Recall Bulletin

PRODUCT EMISSION RECALL

SUBJECT: Oxygen Sensor Fracture

MODELS: 2011-2013 Chevrolet Express
2011-2013 GMC Savana
Cutaway Equipped with Gasoline Engine

(A) First Design Heated Oxygen Sensor (B) Second Design Heated Oxygen Sensor (1) Location of Part Number

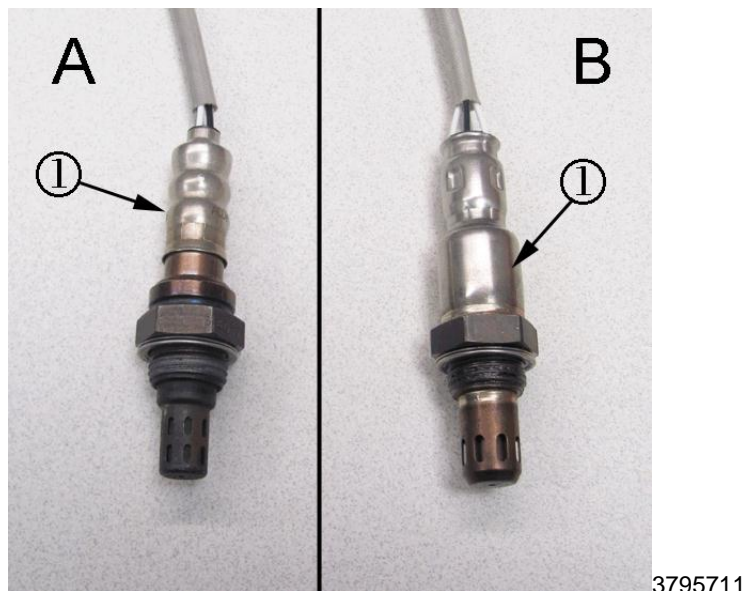
3. Determine if a first design (A) or second design (B) heated oxygen sensor is installed using a light and mirror.

- If a second design (B), P/N 12637297, heated oxygen sensor is installed, no further action is required. Lower the vehicle. Refer to *Lifting and Jacking the Vehicle* in SI.
 - If a first design (A), P/N 12656071 or P/N 12612571, heated oxygen sensor is installed, remove the sensor and replace it with a second design heated oxygen sensor. Refer to *Heated Oxygen Sensor Replacement –Bank 2 Sensor 2* in SI and *Heated Oxygen Sensor Replacement –Bank 1 Sensor 2* in SI.
4. After installing the new heated oxygen sensors, reprogram the ECM. Refer to *Engine Control Module Programming* in this bulletin.
